9-D-23-HZ
APPLICATION FOR CERTIFICATE OF APPROPRIATENESS

616 Luttrell St. 37917
 Fourth and Gill H

Original Print Date: 9/8/2023
 Knoxville/Knox County Planning -- Historic Zoning Commission

Exterior rehabilitation. Applicant proposes removal of the existing non-historic roofline, siding, windows, and doors. Exterior of the house is proposed to be largely reconstructed with a pitched front-gable roof clad in asphalt shingles, an exterior of fiber cement lap siding with cornerboards and window trim, and cedar shingles in the gable fields. Windows will be installed in new fenestrations on the façade, side elevations, rear elevation, and upper gable fields.

EXISTING CONDITIONS

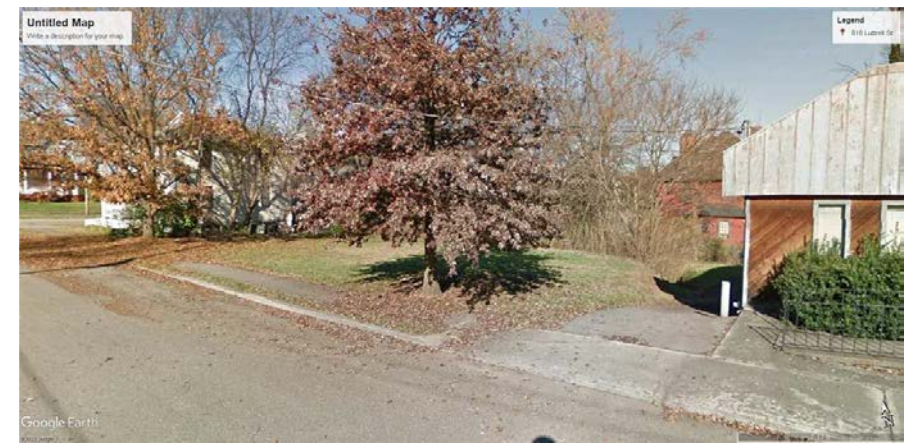
2. The building is highly altered. Historic photos of the building/buildings have not been located but documentation is available via the Sanborn maps and historic aerial photos. The 1917 Sanborn map indicates the building used to be two narrow shotgun houses with front porches, and the 1950 Sanborn map depicts the two buildings as connected with a roof between the two, and individual front porches. By the 1940s, the building was used for commercial purposes. The NRHP nomination from 1985 describes the building as a "one-story frame house with double gabled roof and circular attic vents, severely altered." By the late 1980s or 1990s, the building was modified to feature a false parapet wall on the façade, along vertical wood cladding and single-light commercial-style windows. On the façade, the original two-building form can be seen in the two projecting massings with a recessed front entry.

While reconstructing the original combined roofline could pose construction and maintenance difficulties, the proposed new roof creates the illusion that the building has always been one house. There is no historic evidence for the proposed front-gable roof. Additional design elements should acknowledge the historic evolution of the building from two shotgun houses with front porches to one commercial structure. Such elements could include a revised roofline including two front gables with the primary gable recessed from the façade or a front porch with two gables connected by the proposed pergola.

Staff recommends postponement of Certificate 9-D-23-HZ, allowing the applicant to provide a revised design that more clearly indicates the building's historic evolution. The Commission should discuss the proposed fiber cement lap siding and windows.
